CITY OF VALDEZ
Project Title: VHS Gym Floor Replacement
Project No.: 16-310-9506
Contract No.: 1294

SUBJECT: Addendum No. 2

DATE:	03/16/17
DRAWN:	BJN
CHECKED:	DJD
PROJECT:	1704
DRAWING TITLE:	GYM DEMOLITION PLAN
REVISIONS:	ADDENDUM #2
SHEET NO:	A1.1

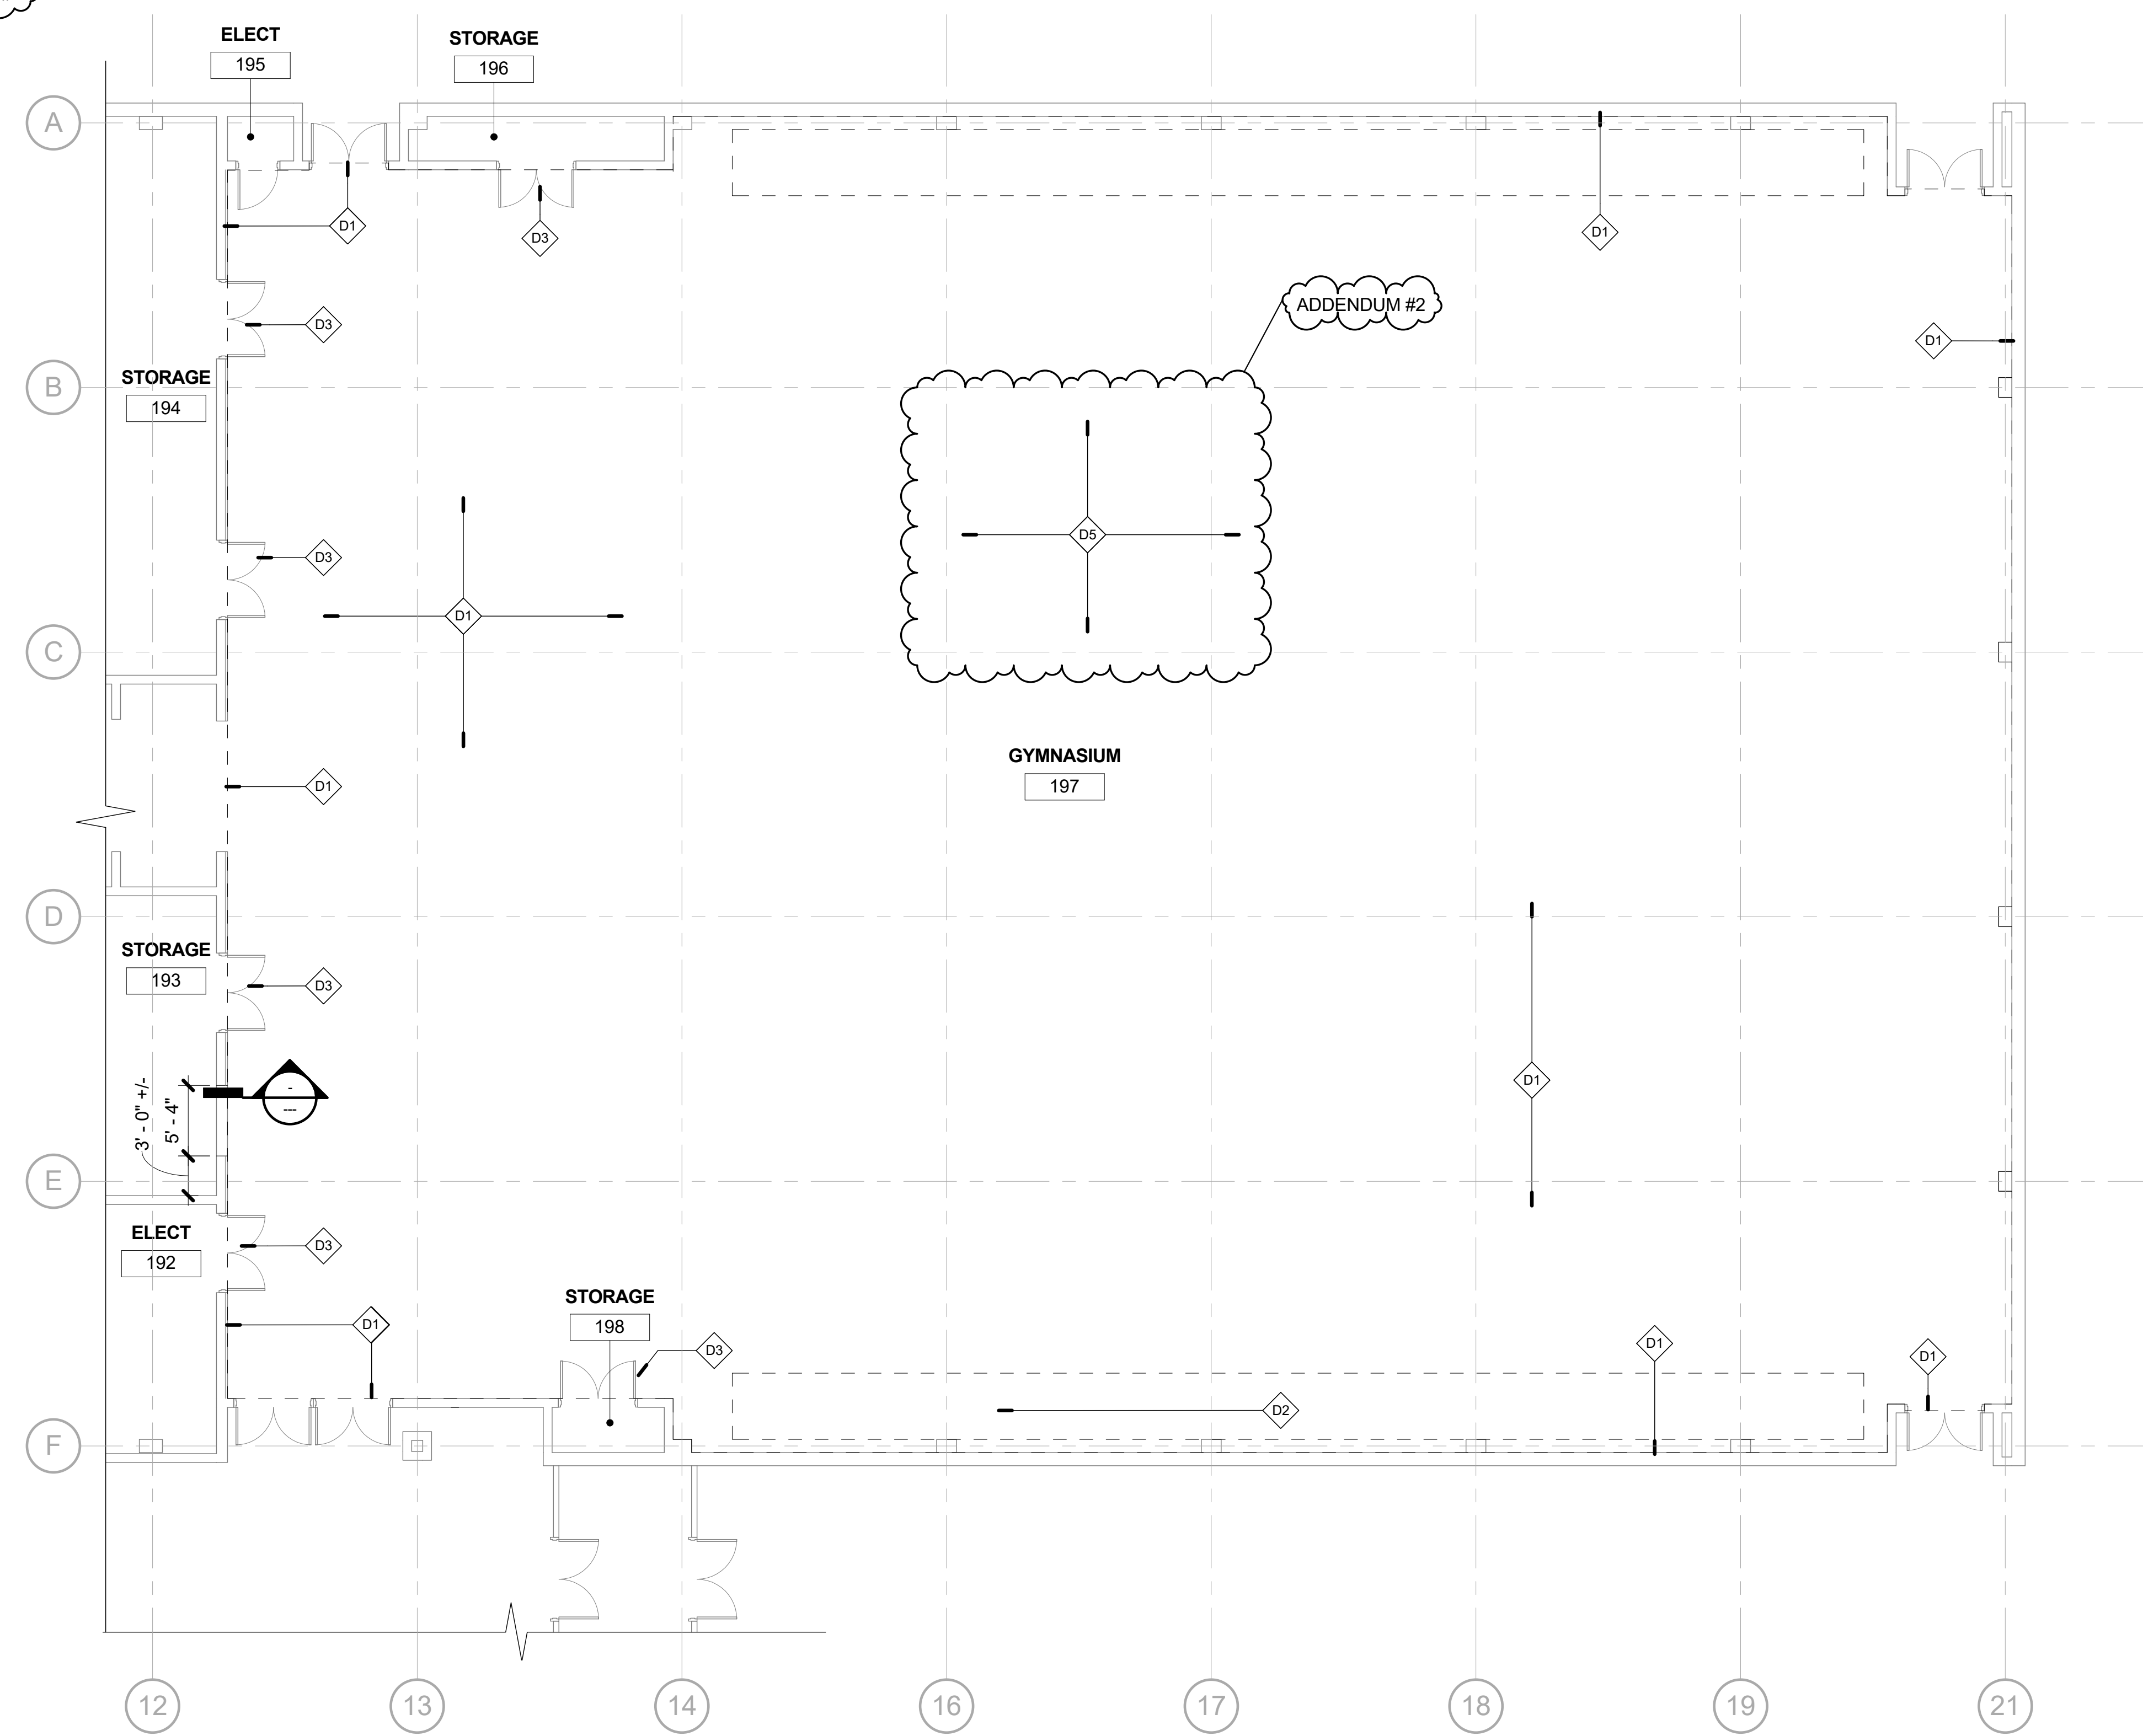
AD2-3. SHEET A1.1: **DELETE** Keynote Number #8 in its entirety.

AD2-4. SHEETS A1.1 & A2.2: **REPLACE** sheets in their entirety with attached Sheets A1.1 & A2.2.

DATE:	03/16/17
DRAWN: BJN	
CHECKED: DJD	
PROJECT: 1704	
DRAWING TITLE: GYM FLOOR PLAN	
REVISIONS: ADDENDUM #2	
SHEET NO:

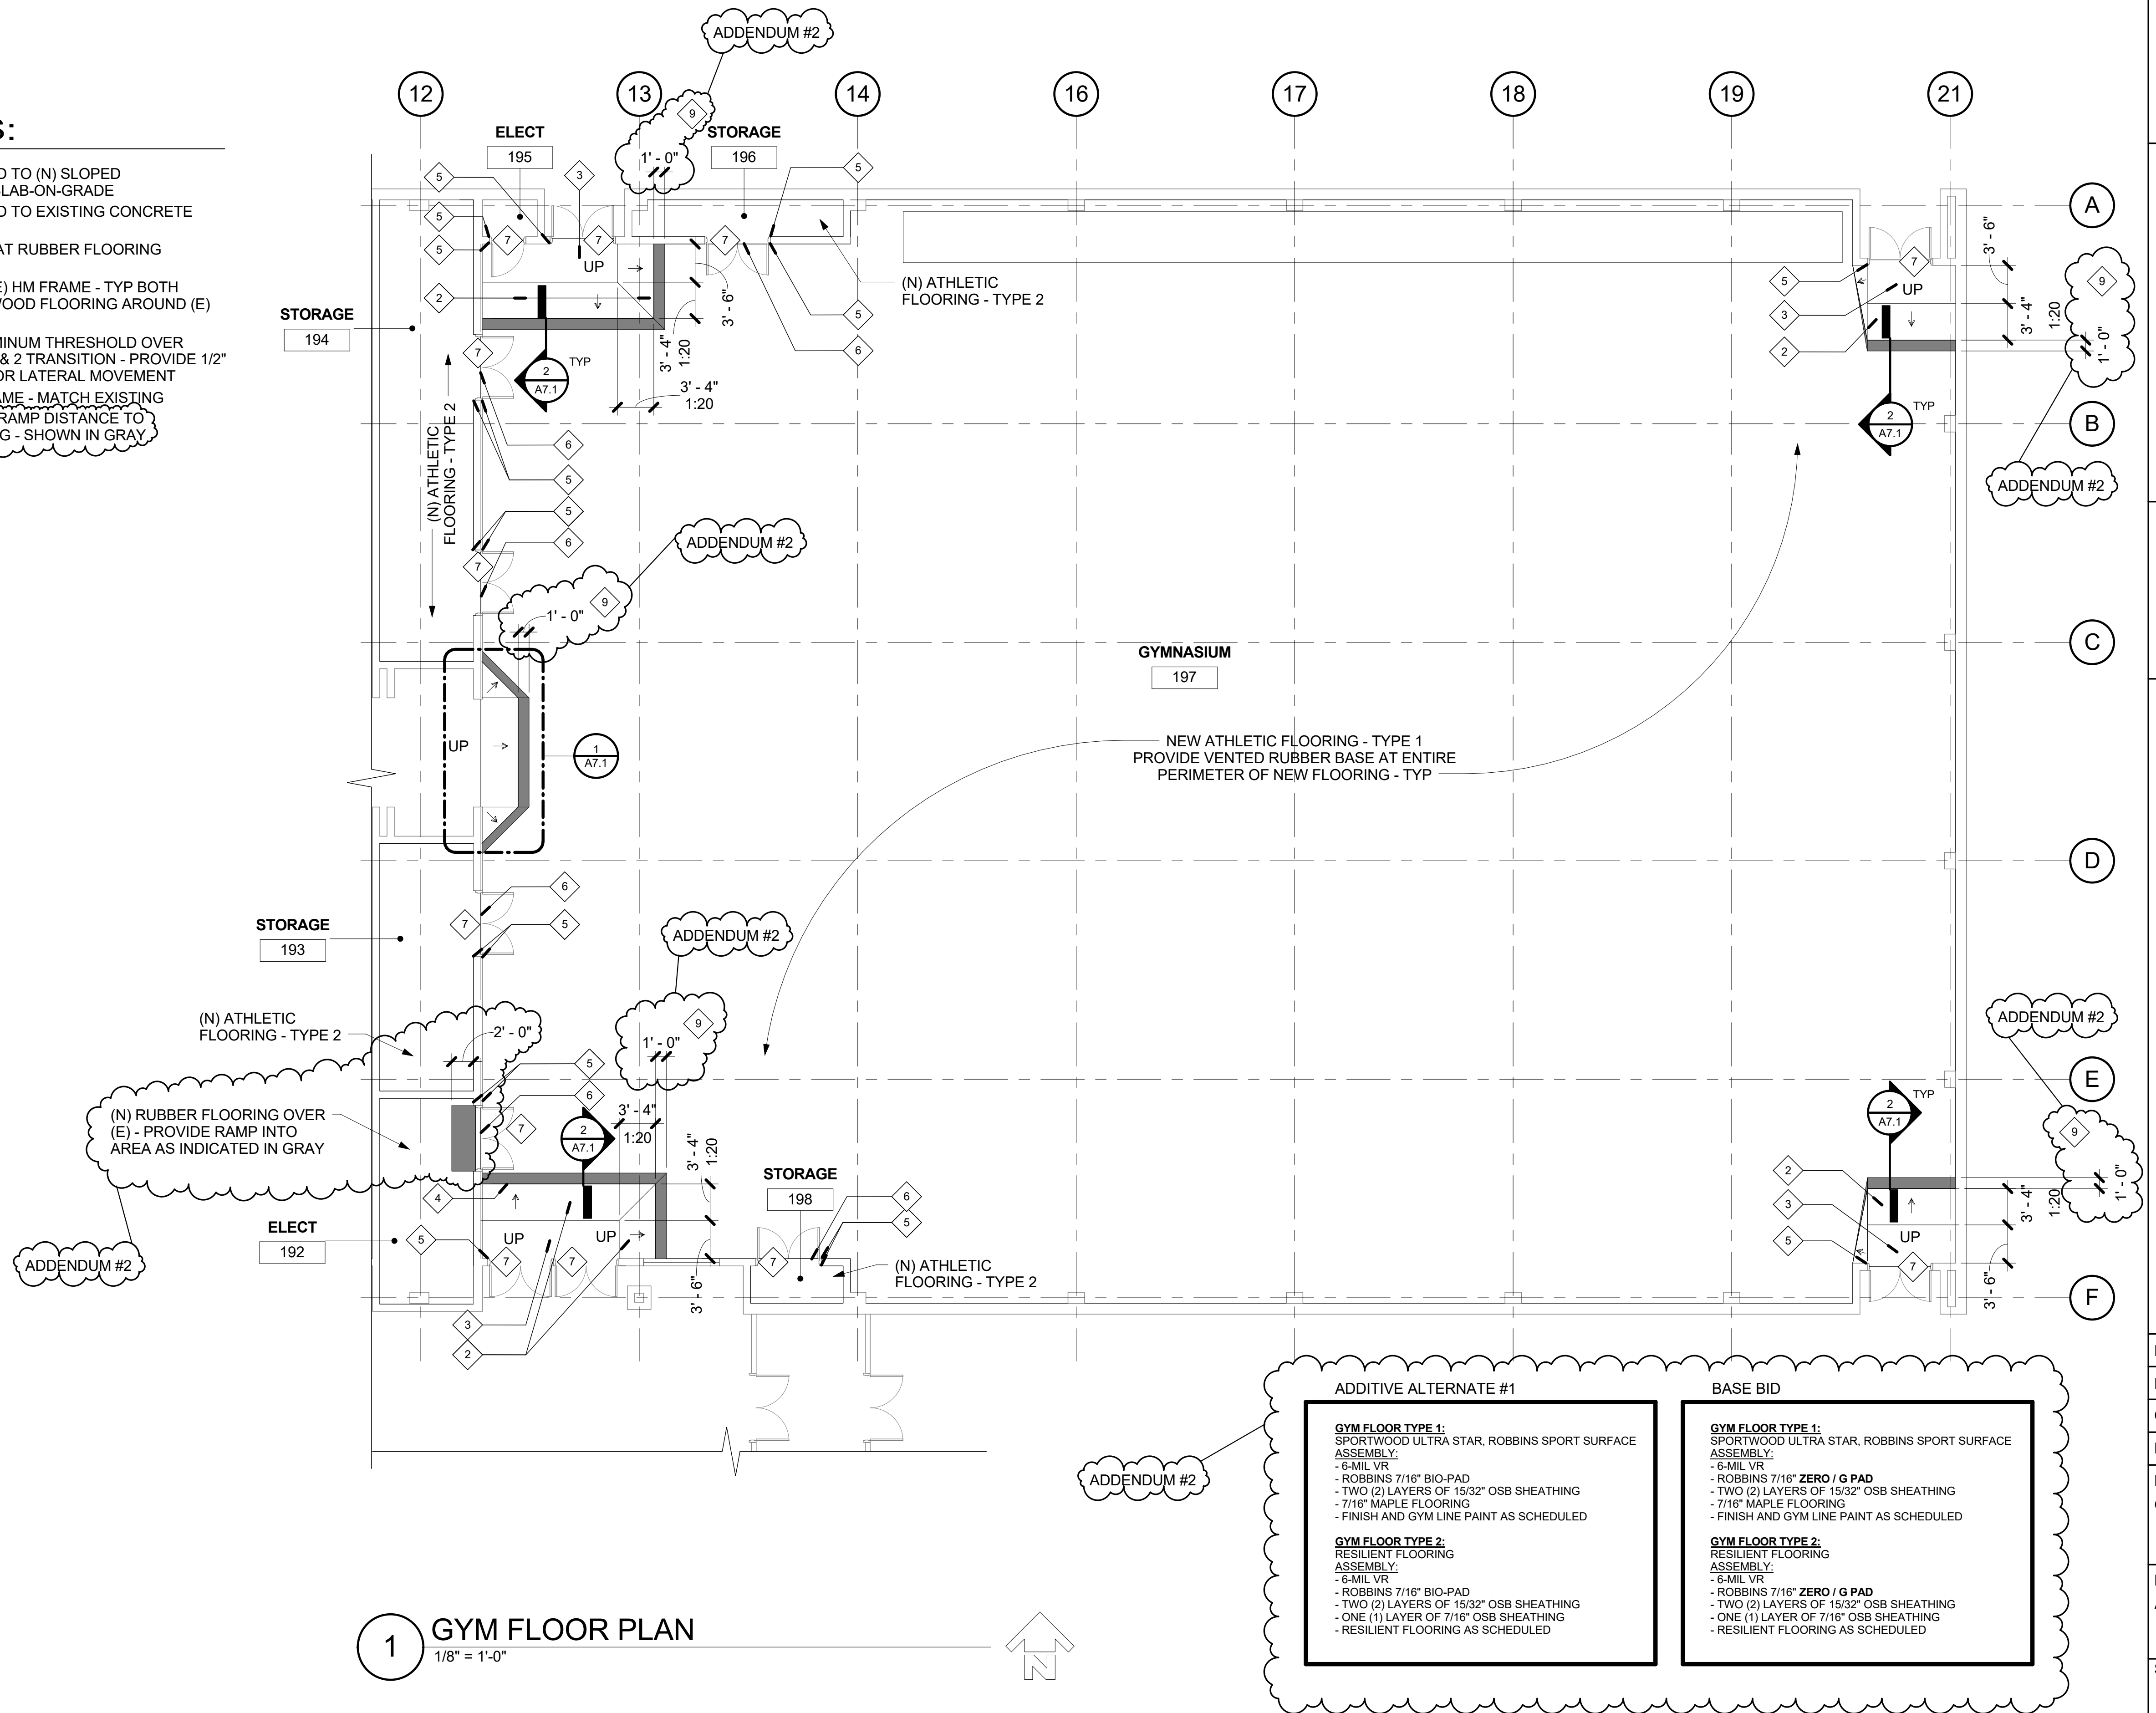
3. Sheet A2.2 Calls for room 192 to receive athletic flooring typ 2. I do not see where this is possible as the perimeter has conduit penetrations and there is a couple transformers in the room as well. There is no way to finish this room nor base it as everything at the perimeter would be exposed and a catchall for dirt. My suggestion would be to make a ramp into the room. this can stop flush with the interior wall and door frame. If ramp needs to meet ADA it could be extended further into the room. Is a ramp at electrical room 192 acceptable?

RESPONSE: Addressed in Addendum above.
